# ENCLOSURE I

## CORE OPERATING LIMITS REPORT SUBMITTAL 89-03

### TECHNICAL SPECIFICATION REVISION SUMMARY

**FIGURE 3.2.1-1**  
**MAXIMUM AVERAGE PLANAR LINEAR HEAT GENERATION RATE (MAPLHGR)**  
**VERSUS AVERAGE PLANAR EXPOSURE BPSRB094**

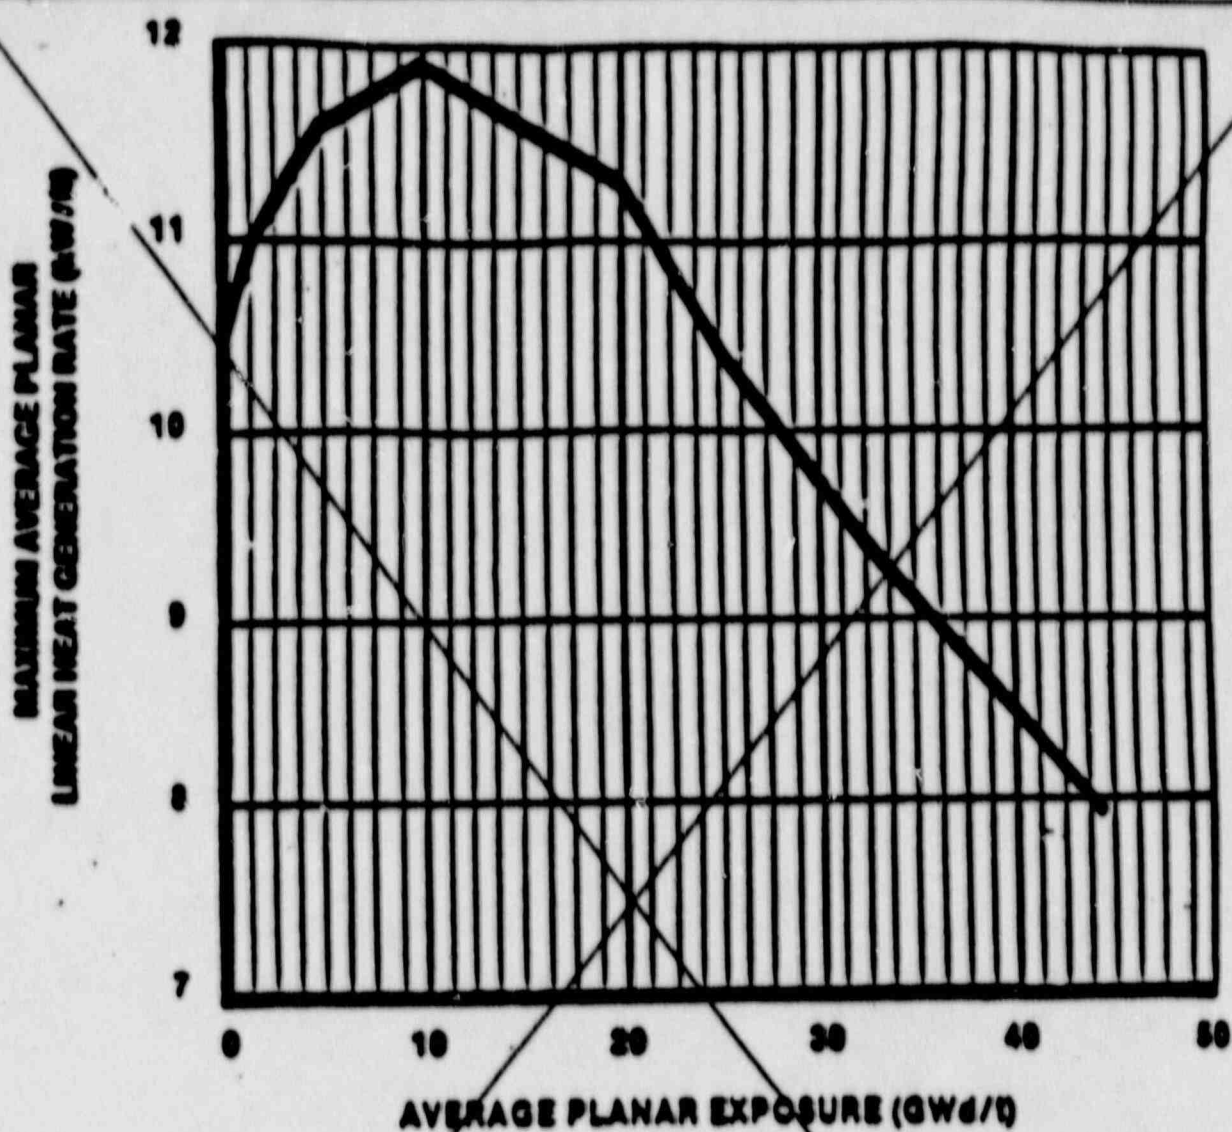
TRANSFER TO CCLR

FIGURE 3.2.1-2  
MAXIMUM AVERAGE PLANAR LINEAR HEAT GENERATION RATE (MAPLHGR)  
VERSUS AVERAGE PLANAR EXPOSURE BPBSRB163

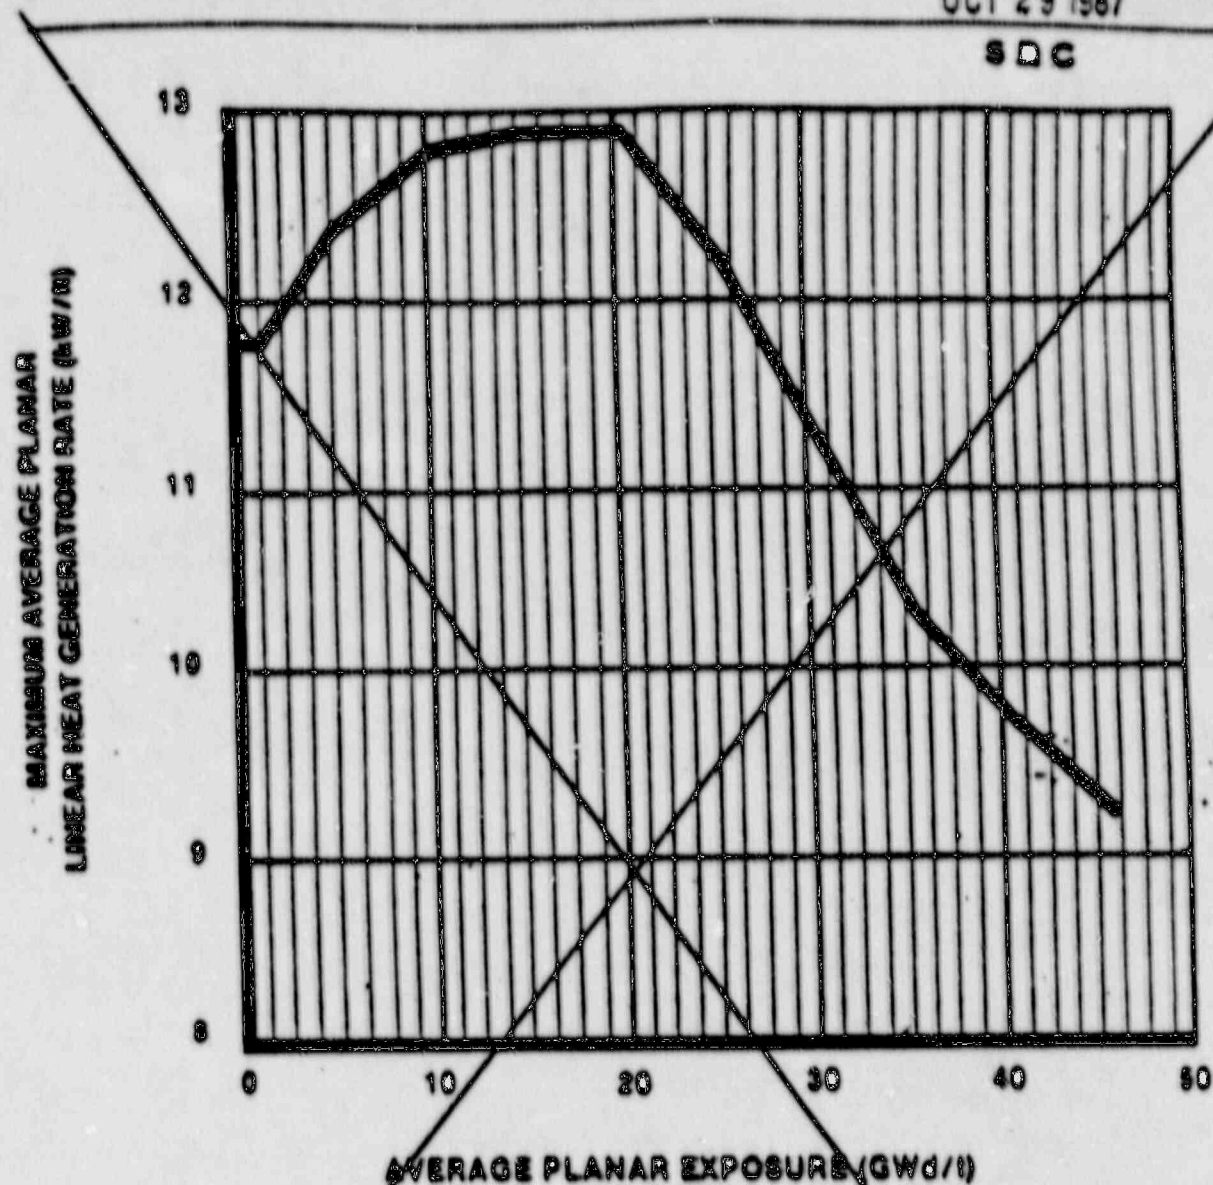
<u>FIGURE</u>	<u>TITLE</u>	<u>PAGE</u>
<del>3.2.1-1</del>	<del>Maximum Average Planar Linear Heat Generation Rate (BP8SRB094).....</del>	<del>3/4 2-2</del>
<del>3.2.1-2</del>	<del>Maximum Average Planar Linear Heat Generation Rate (BP8SRB163).....</del>	<del>3/4 2-3</del>
<del>3.2.1-3</del>	<del>Maximum Average Planar Linear Heat Generation Rate (BP8SRB248).....</del>	<del>3/4 2-4</del>
<del>3.2.1-4</del>	<del>Maximum Average Planar Linear Heat Generation Rate (BP8SRB278).....</del>	<del>3/4 2-5</del>
<del>3.2.1-5</del>	<del>Maximum Average Planar Linear Heat Generation Rate (BP8SRB299).....</del>	<del>3/4 2-6</del>
<del>3.2.1-6</del>	<del>Maximum Average Planar Linear Heat Generation Rate (BP8SRB305).....</del>	<del>3/4 2-6A</del>
<del>3.2.3-1</del>	<del>MCPR.....</del>	<del>3/4 2-9</del>
<del>3.2.3-2</del>	<del>MCPR.....</del>	<del>3/4 2-10</del>

FIGURE 3.2.3-1

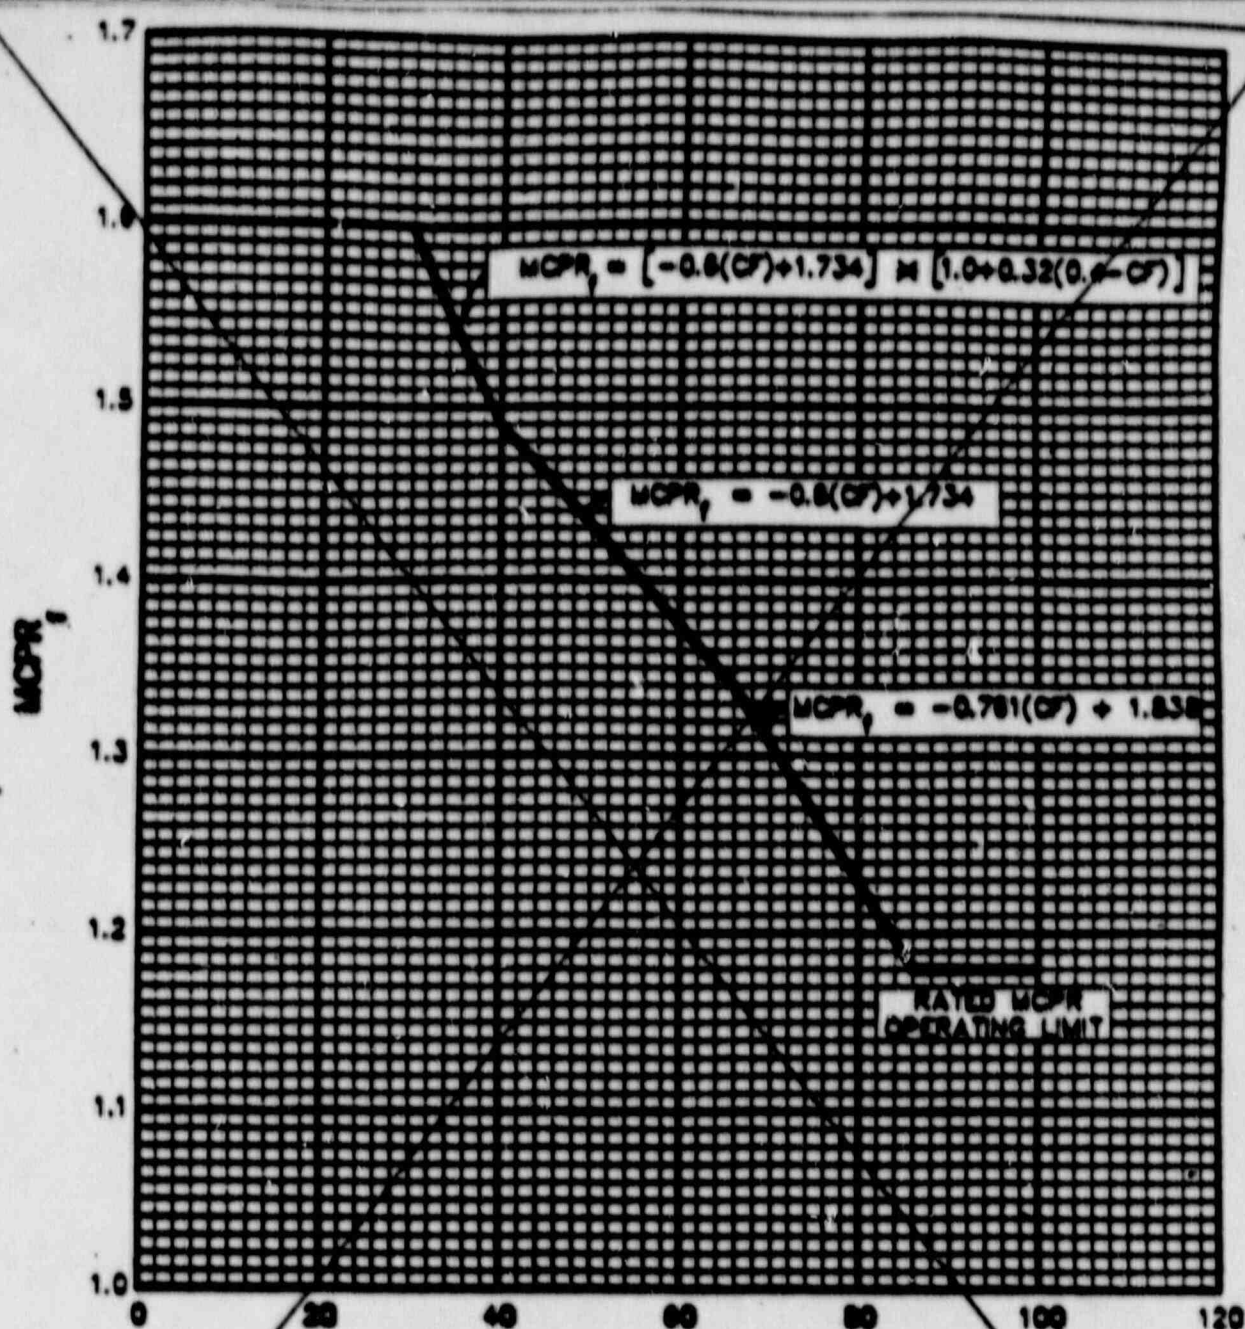
3.2.3 The MINIMUM CRITICAL POWER RATIO (MCPR) shall be equal to or greater than both MCPR<sub>f</sub> and MCPR<sub>p</sub> limits at indicated core flow and THERMAL POWER as shown in Figures 3.2.3-1 and 3.2.3-2. *specified in the COLR.*
